1.0 Thomas Peacocke site: Plutus Developments Extension of time granted until 25 July 2028

4.00 48 Ferry Road. Former night club.

5.00 Bridge Point Studios.

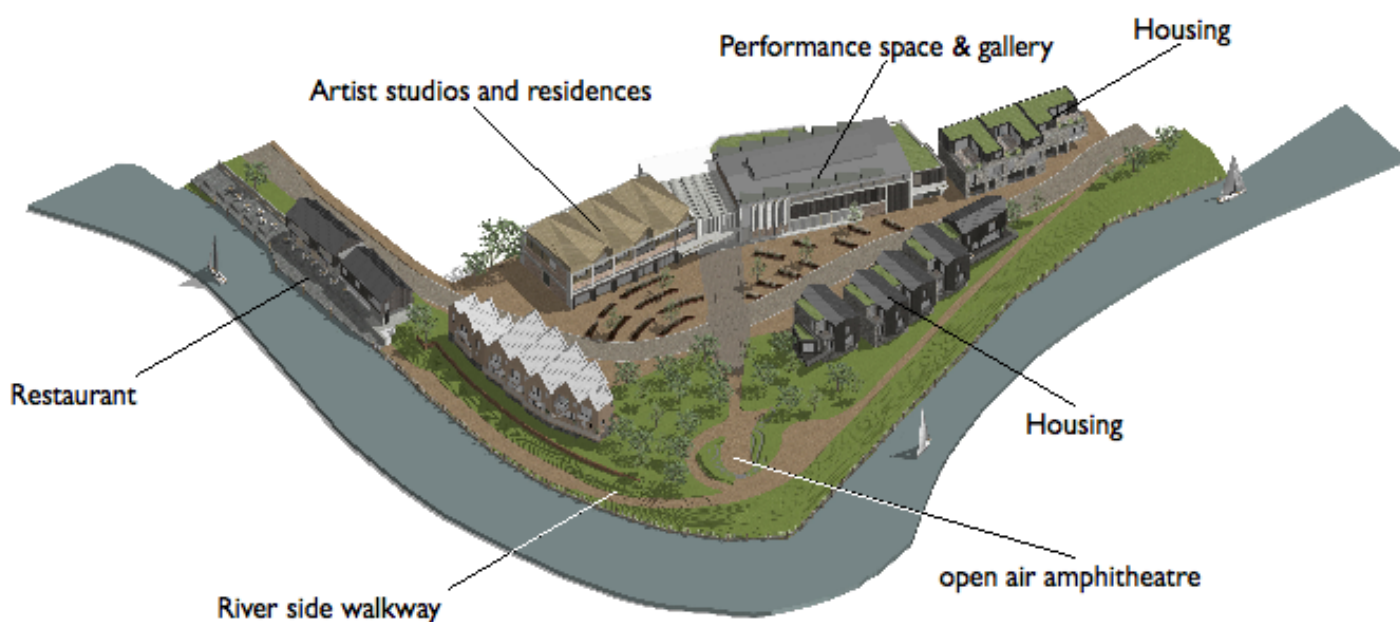
We have objected on grounds of design, overlooking and parking issues.

The current parking policy in the RNP V11 would require 16 spaces, ESCC have indicated that their model would require 9 unallocated spaces or 12 allocated plus visitors but have recently accepted 6 spaces.

One of their arguments is that there would have been a much higher parking provision for the night club. In fact there were no spaces and who in any event takes their car to a night club. Also it was only used at night when the car parks in Rye are used less.
